SYAMA PRASAD MOOKERJEE PORT,KOLKATA
Erstwhile KOLKATA PORT TRUST
HALDIA DOCK COMPLEX

Tender No. SDM (P&E)/T/ 62 /2019-2020

Supply, Installation, Testing and Commissioning of 11kV/3.3kV/415V Panel along with allied works for augmentation of GC Berth Sub-station including construction of sub-station building at GC Berth area of Haldia Dock Complex, SMP, Kolkata.

ADDENDUM - IV

DY. MANAGER (I & C F)	SR.DY. MANAGER (I & C F)	SCALE:-1:150	DATE:-04.03.2020	DRG. NO:-H-S-STN/GCB-02A1
----------------------------	-------------------------------	--------------	------------------	---------------------------

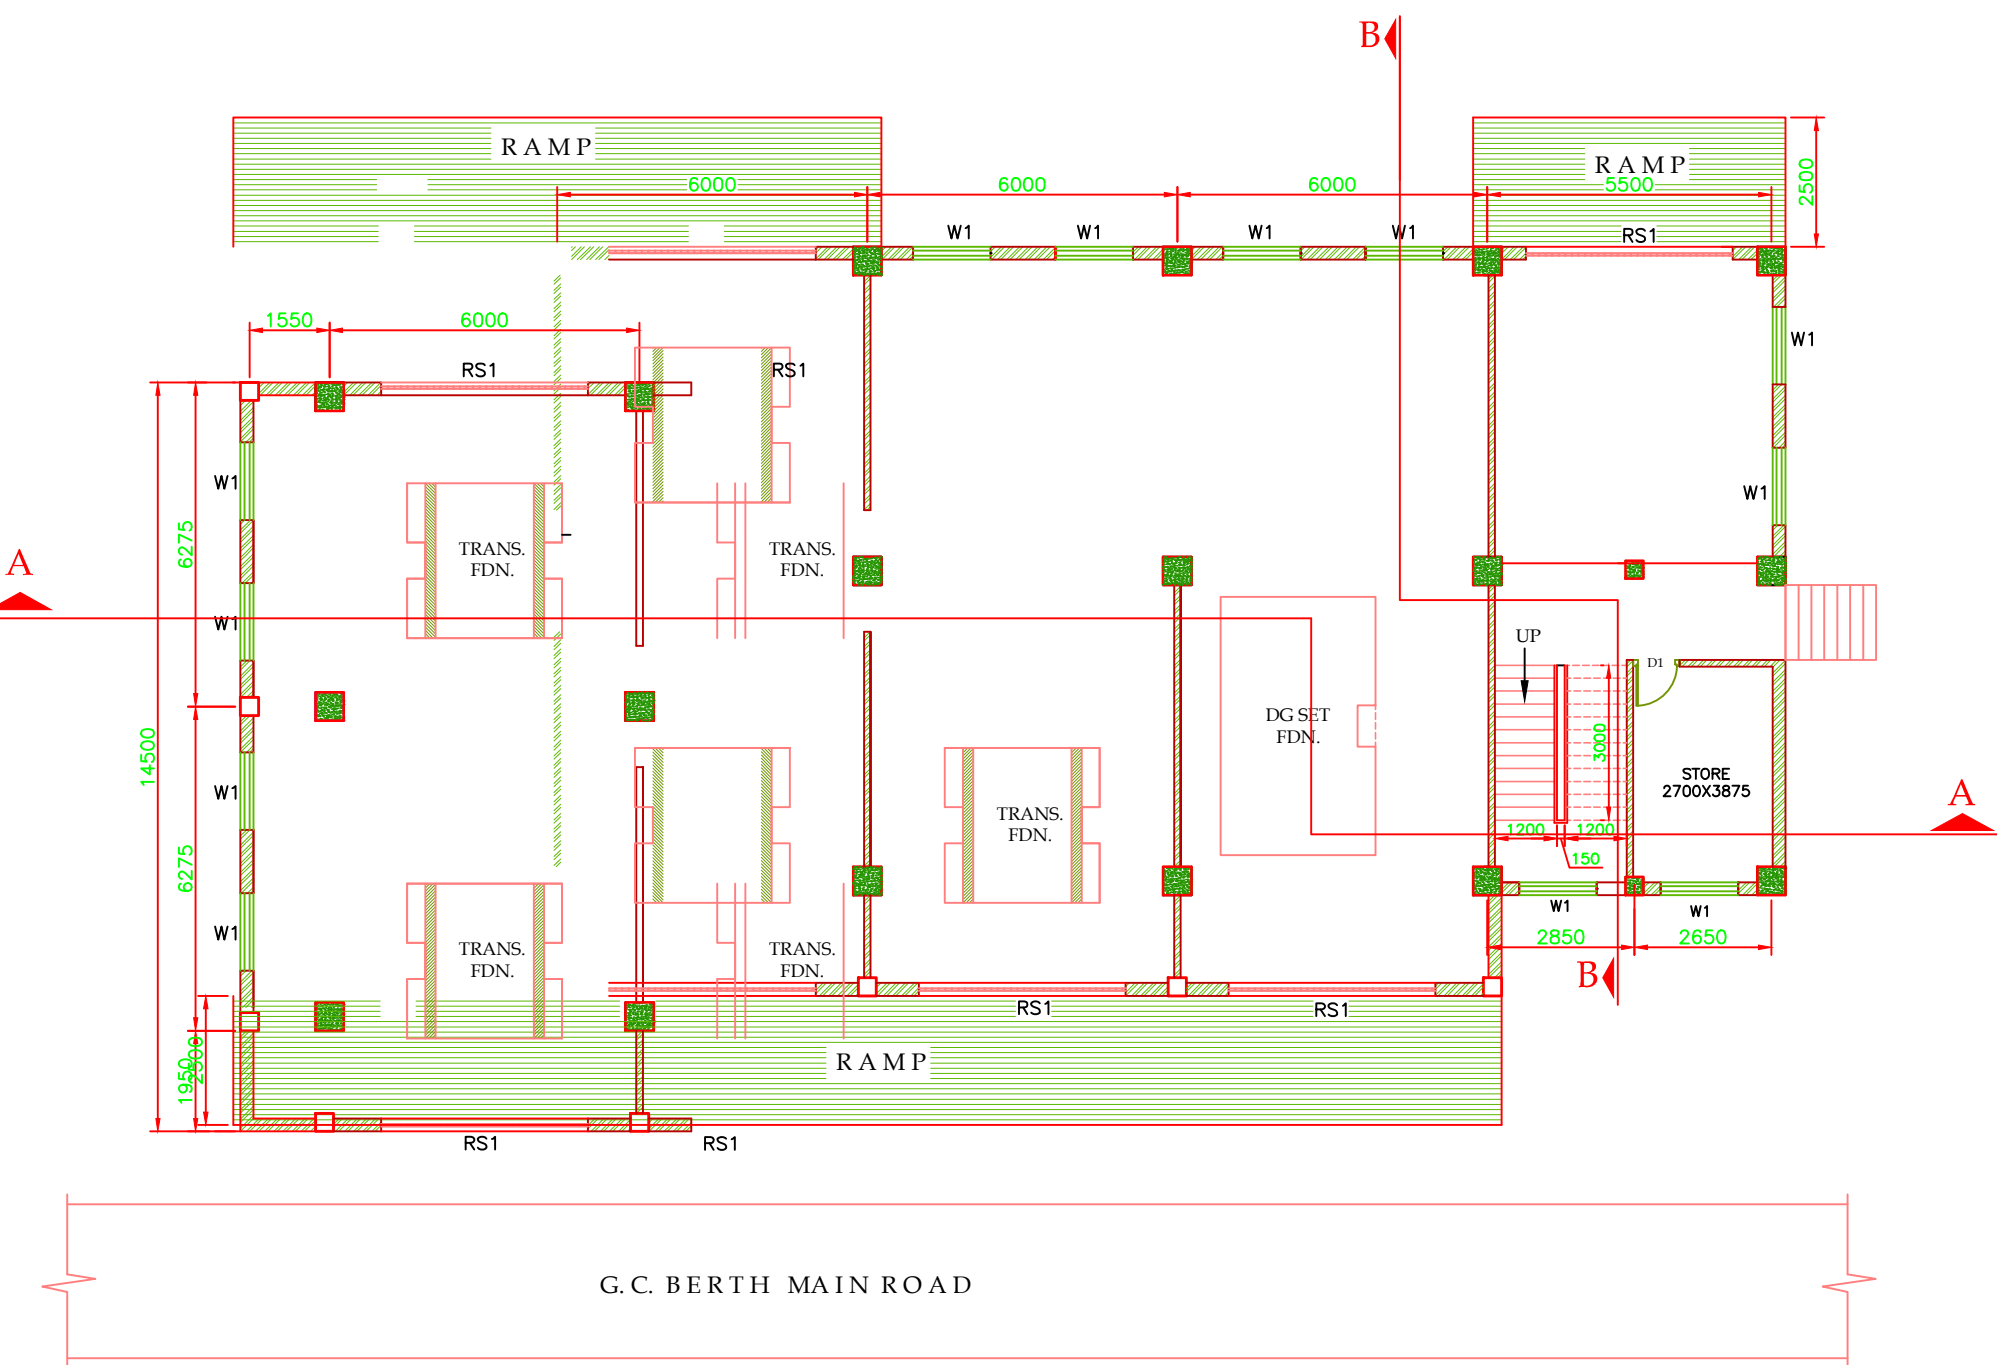
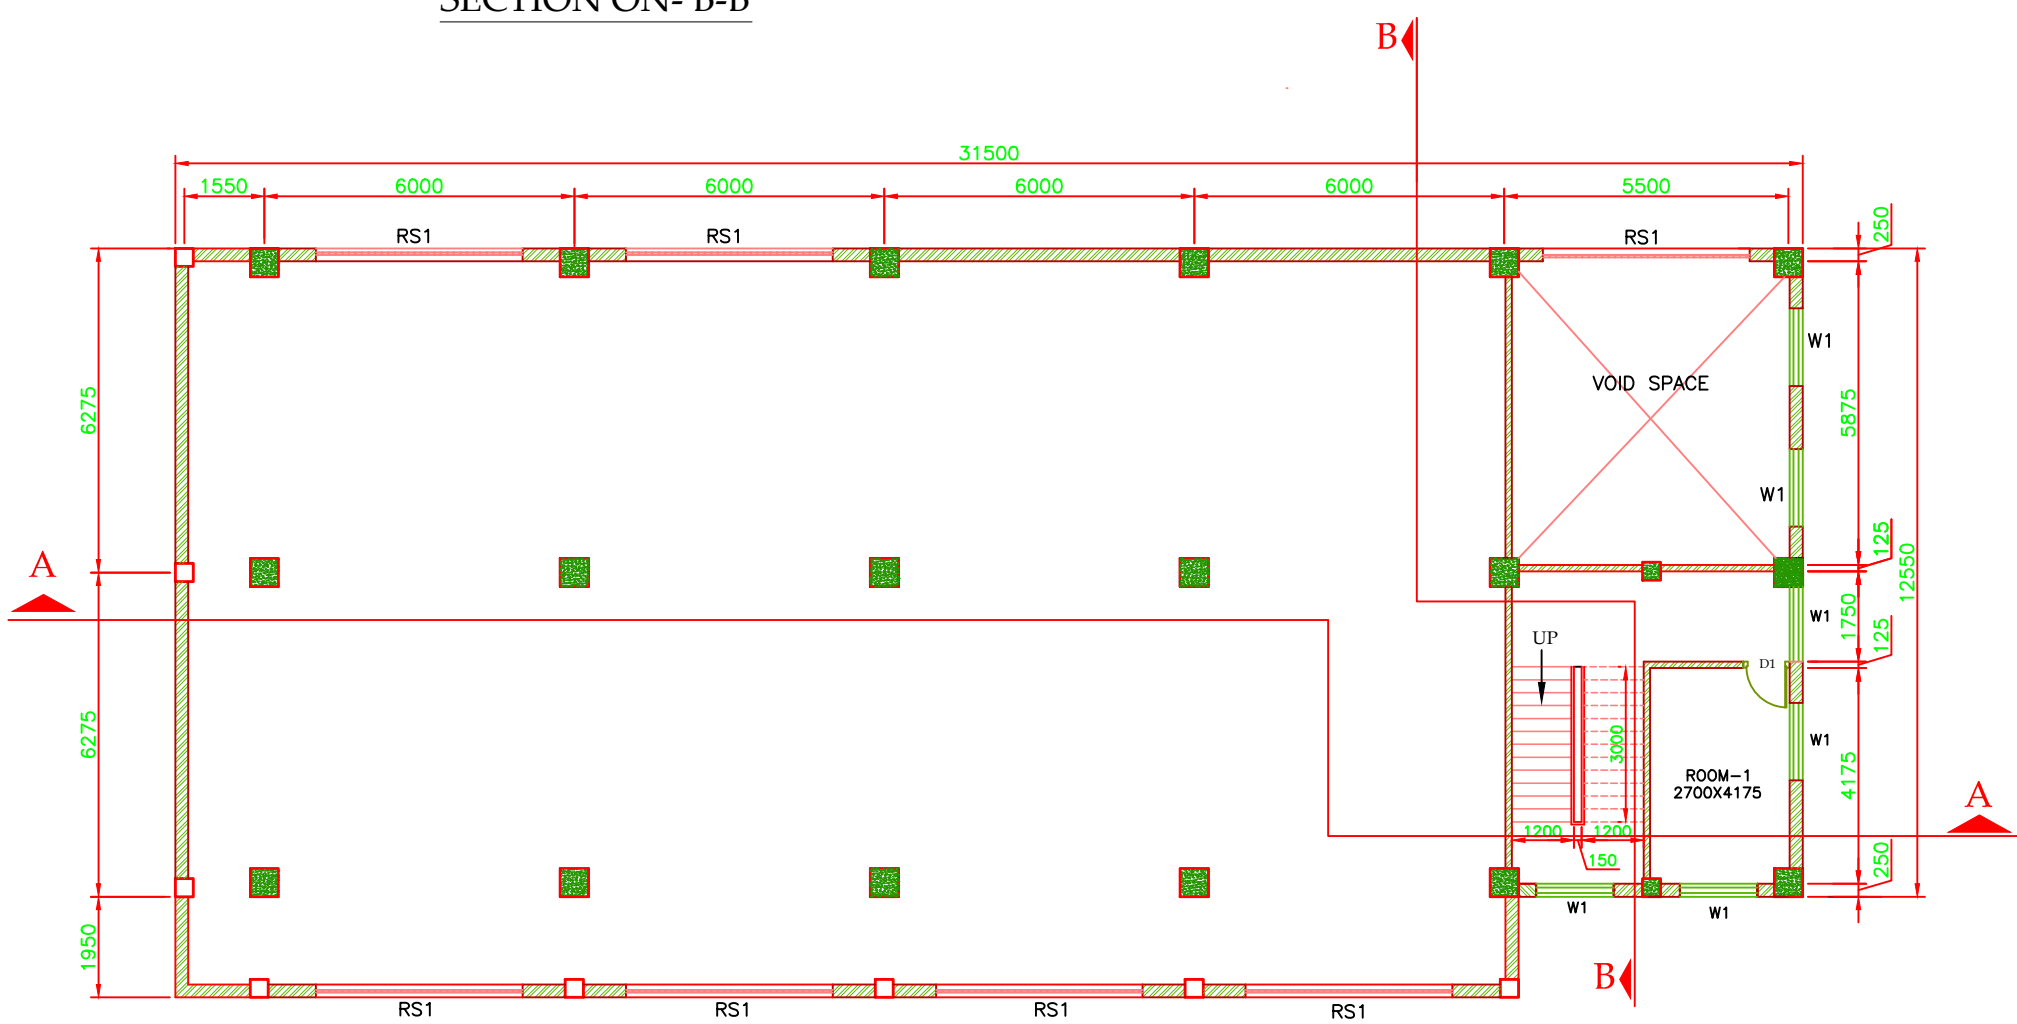
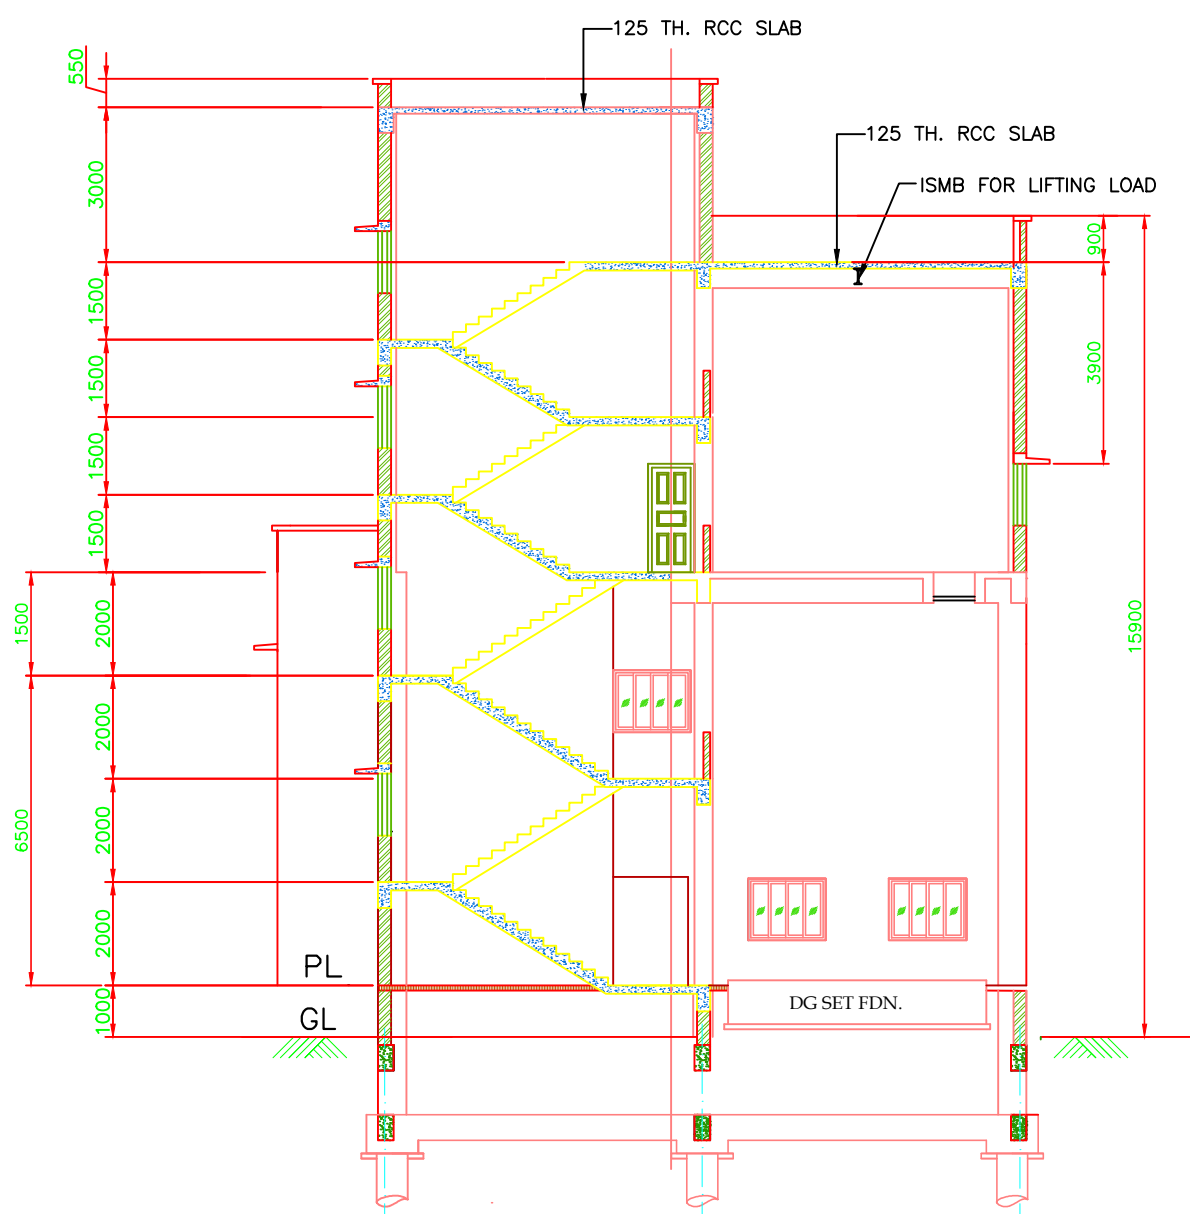
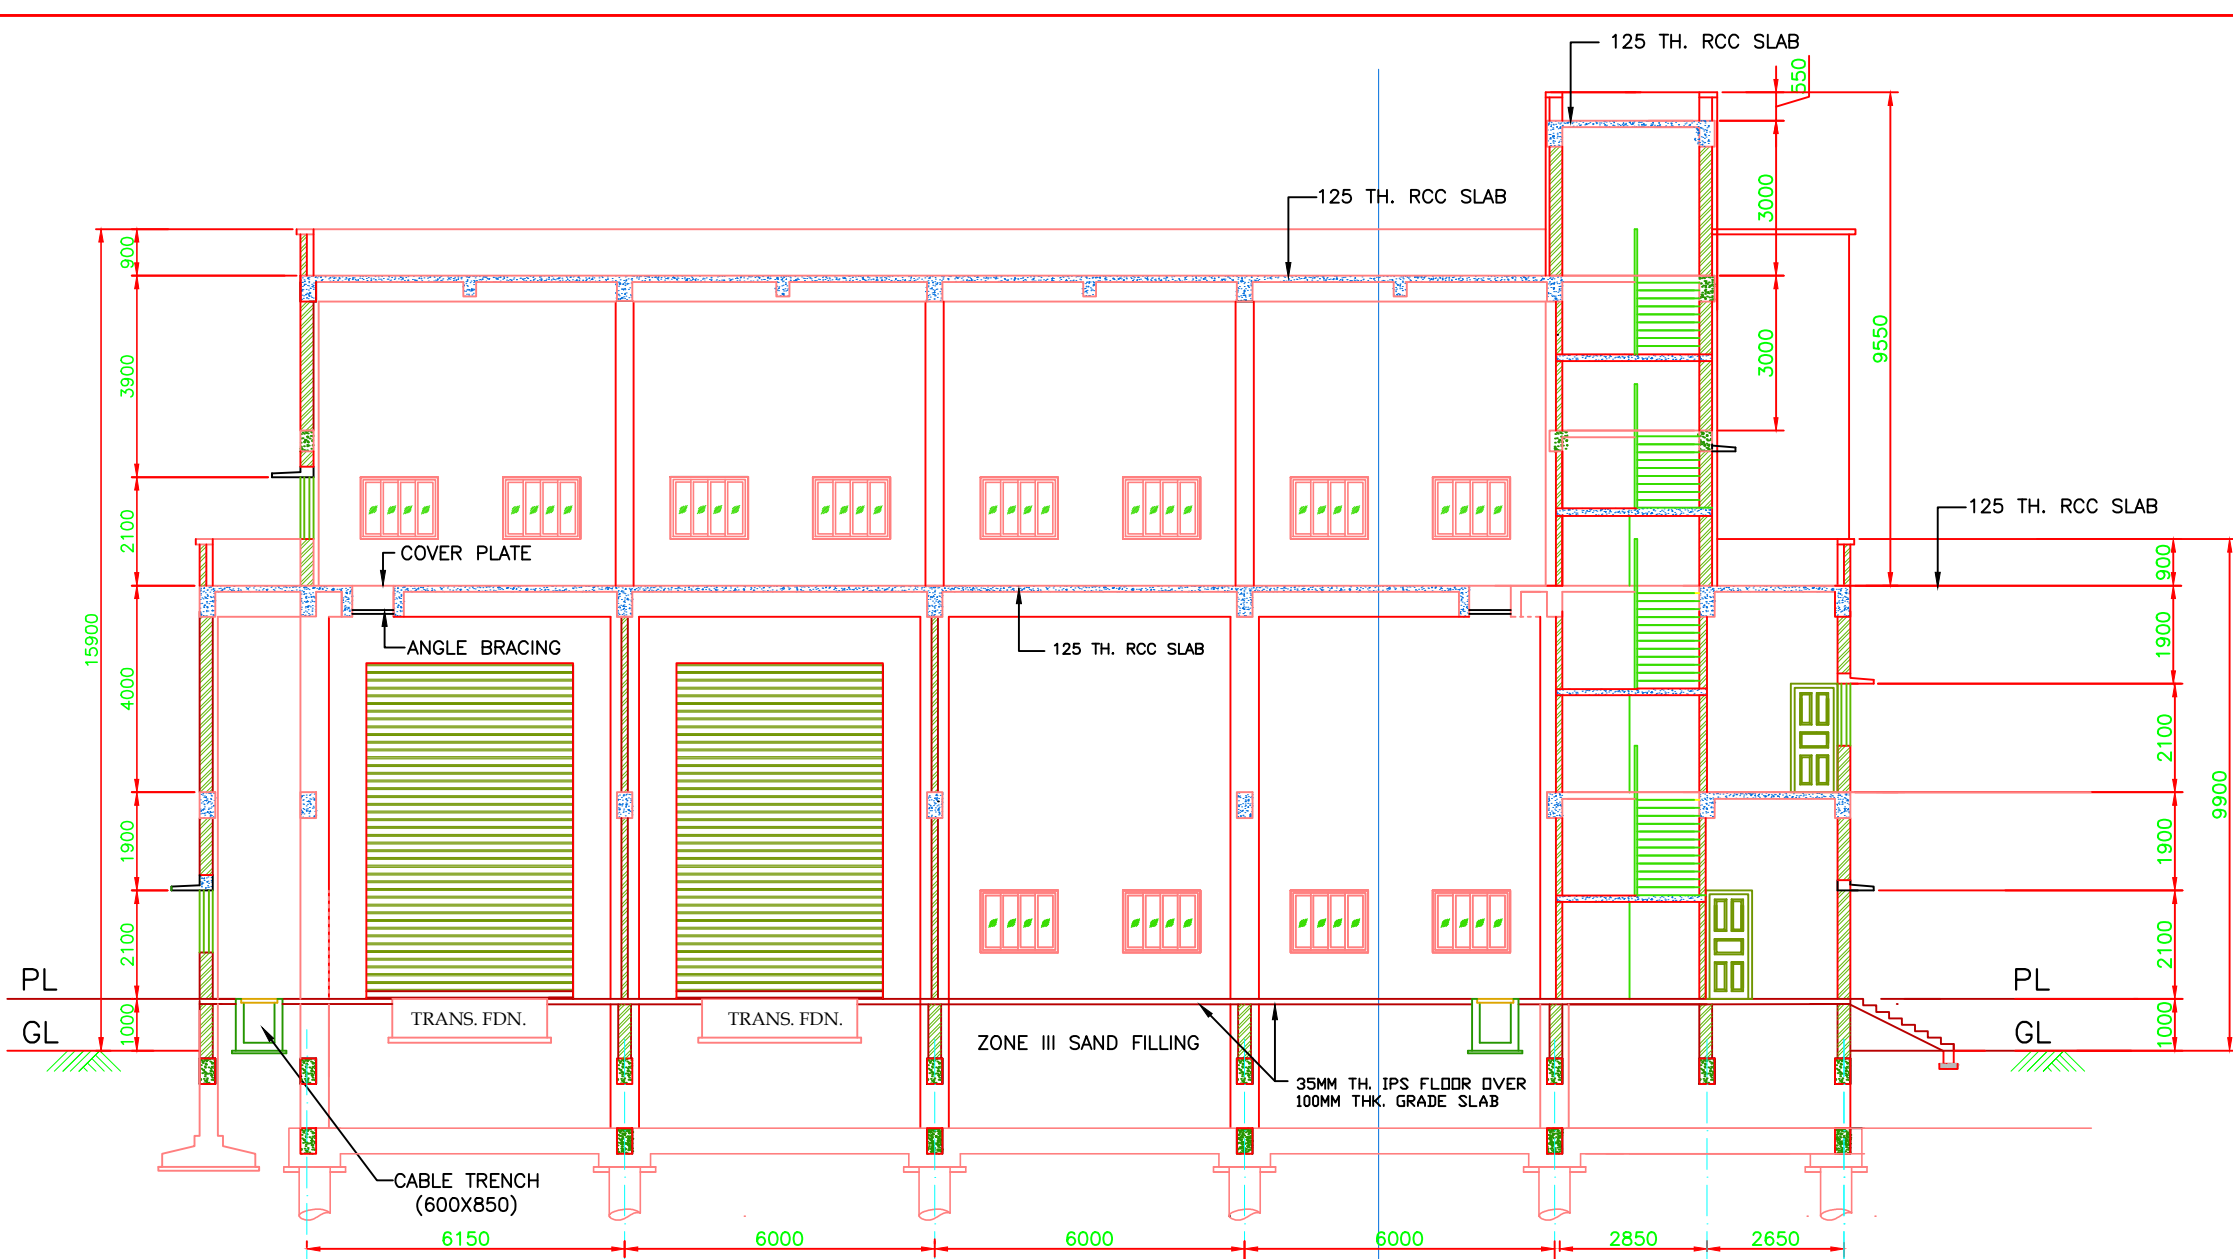
3.	155	Part B Wiring and electrification of sub-station. Item No.1	Building dimension (35x12x8) Mtrs. Ground floor (35x12x6) Mtrs.1 st Floor	Building dimension (31.5 x 14.5 x 8) Mtrs. -Ground floor (31.5 x 14.5 x 6) Mtrs.-1 st Floor

13.	Drawings	Please provide the SLD for HT & LT Panels.	Please see addendum.
14.		In BOQ Building dimension (35x12x8) Mtrs Ground floor (35x12x6) Mtrs. 1st Floor is given. But in drawing ground	Please see addendum

Sl. No.	Reference	Queries of the firms	HDC, SMP's Clarifications
		floor, 1st floor (8mtr-Height) & Hall room (9mtr-Height) is mentioned. Please provide us Civil & Structural work drawing for Substation building.
